Access Compliance Report

(Curb Ramps)

Intersection ID: 49928	Main Street: PAXTON_RUN_RD	Cross Street: CAMPBELL_HALL_CT	Location: NE
ADA ID: 16BAAA54841C	Ramp Type: Perp	Initial Pass/Fail: Fail	Overall Compliance: No
Codes/Mitigation Info/Possible Solution			Severity Score: 25
			Field Measurements/Component Compliance

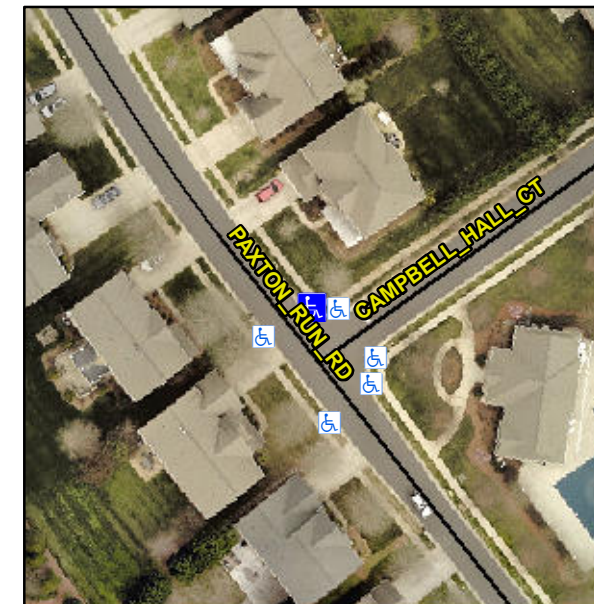
Not Found, R304.5.3

Compliance	Description	Data	Compliance	Description	Data
N/A	Ramp Length (in)	48.0	Yes	Ramp Slope (%)	5.6
Yes	Ramp Width (in)	48.0	No	Ramp XSlope (%)	8.0
N/A	Flare Type LT	N/A	N/A	Flare Type RT	N/A
N/A	Flare Slope LT (%)	N/A	N/A	Flare Slope RT (%)	N/A
N/A	Flare Traversable LT?	N/A	N/A	Flare Traversable RT?	N/A
N/A	Landing Length (in)	N/A	N/A	DWS Provided?	N/A
N/A	Landing Width (in)	N/A	N/A	DWS Contrast?	N/A
N/A	Landing Slope (%)	N/A	N/A	DWS Length (in)	N/A
N/A	Landing X Slope (%)	N/A	N/A	DWS Full Width?	N/A
N/A	Landing Curb? (Y/N)	N/A	N/A	DWS Offset (in)	N/A
N/A	Shared Landing?	N/A			
N/A	Gutter Ponding?	N/A	N/A	Gutter Slope (%)	N/A
N/A	Gutter Lip Ht (in)	N/A	N/A	Gutter X Slope (%)	N/A
N/A	Painted X Walk1?	No	N/A	Painted X Walk2?	N/A
	X Walk 1 Direction	To SW		X Walk 2 Direction	N/A
N/A	X Walk 1 Width (in)	N/A	N/A	X Walk 2 Width (in)	N/A
	X Walk 1 Slope (%)	3.9		X Walk 2 Slope (%)	N/A
	X Walk 1 X Slope (%)	4.1		X Walk 2 X Slope (%)	N/A

Remove & Replace Entire Ramp.
